From: John Feith [
Sent: Tuesday, January 27, 2015 11:13 AM
To: Martin, Alan
Cc: RSlayton@erdman.com
Subject: RE: Urban Design Commission meeting on 1200 E Washington

I'm including the final Tenney Lapham Neighborhood Association Steering Committee report for the 1200 E. Washington development proposal to be presented tomorrow 1/28/15 (file 36899).

Summary Report
TLNA Steering Committee Meeting for
McGrath Property Group Proposal for the 1200 N Block of E. Washington
January 26, 2015

VIEW FROM BACKYARDS

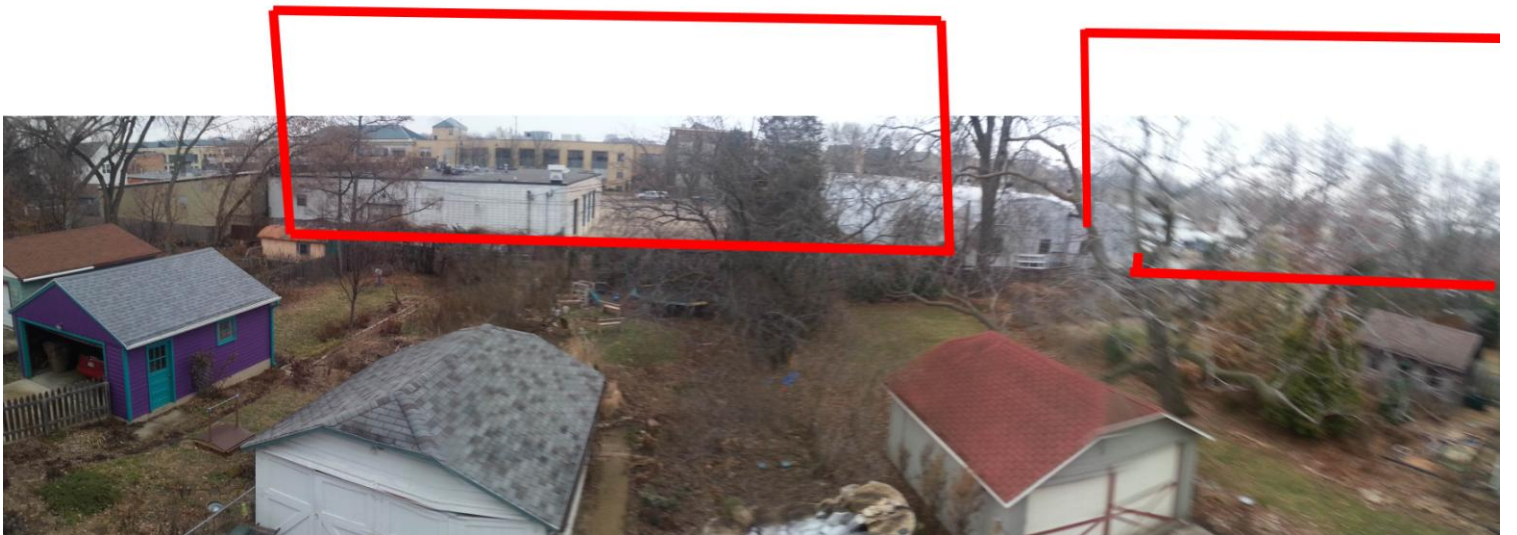
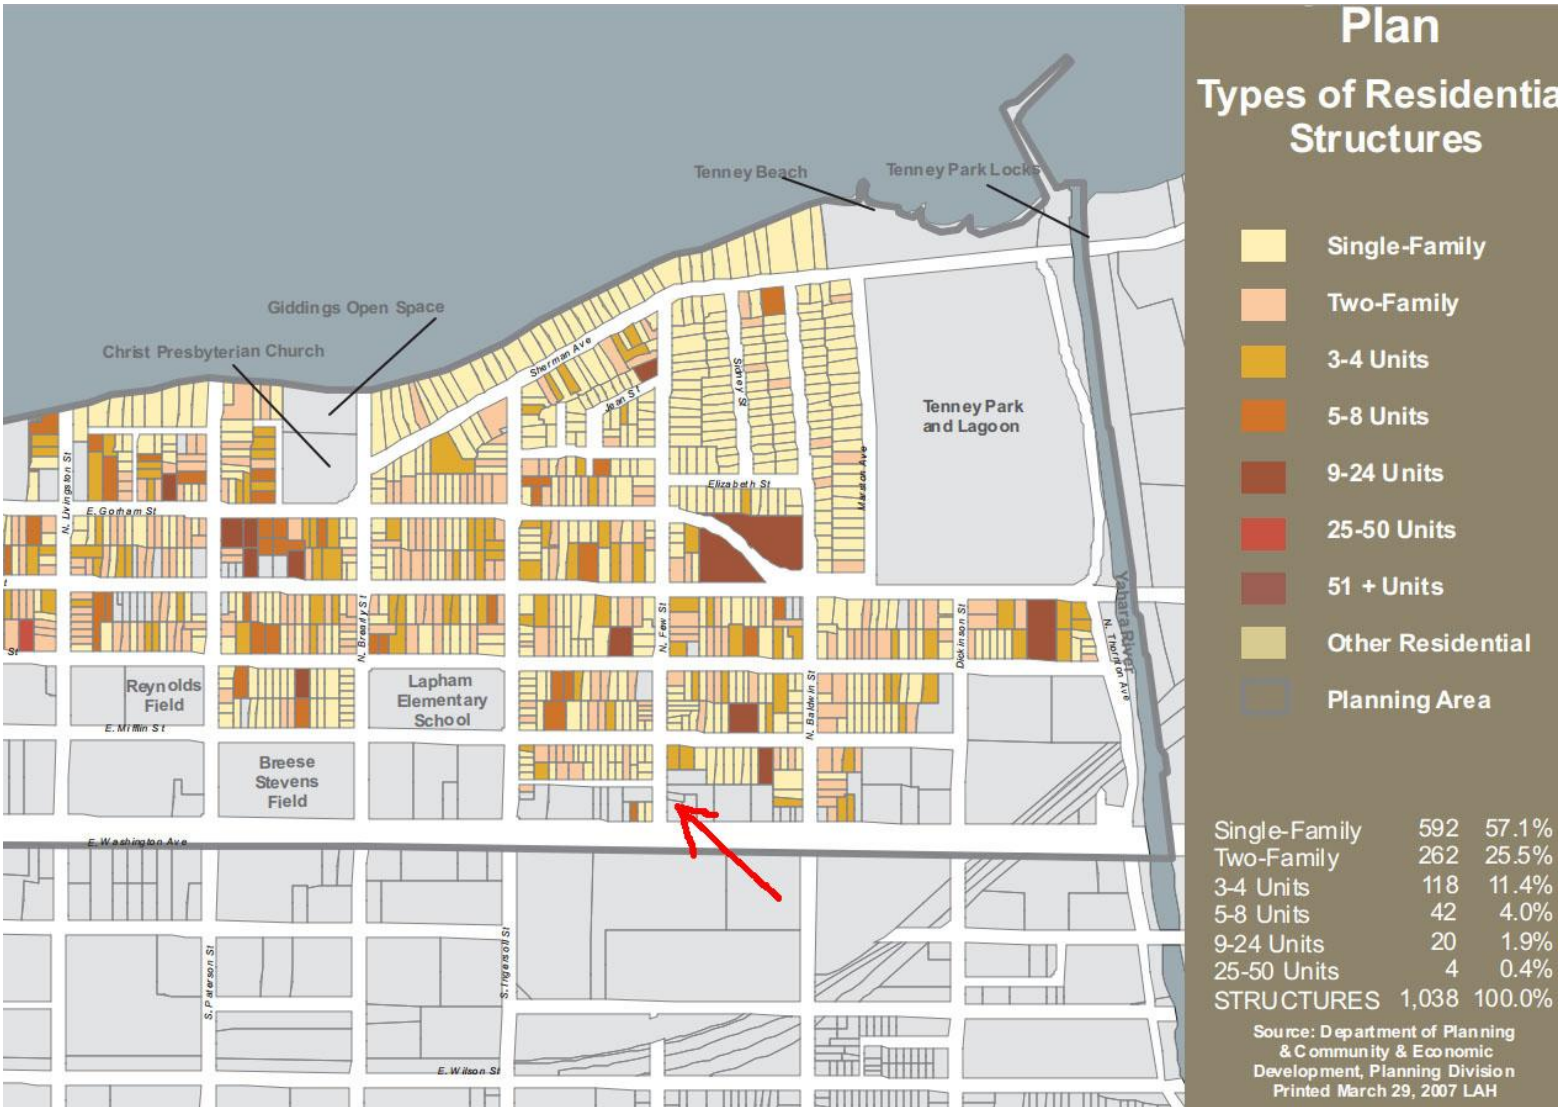
Sunrise and morning shadow estimates/extrapolations for 4.5 story/55' building
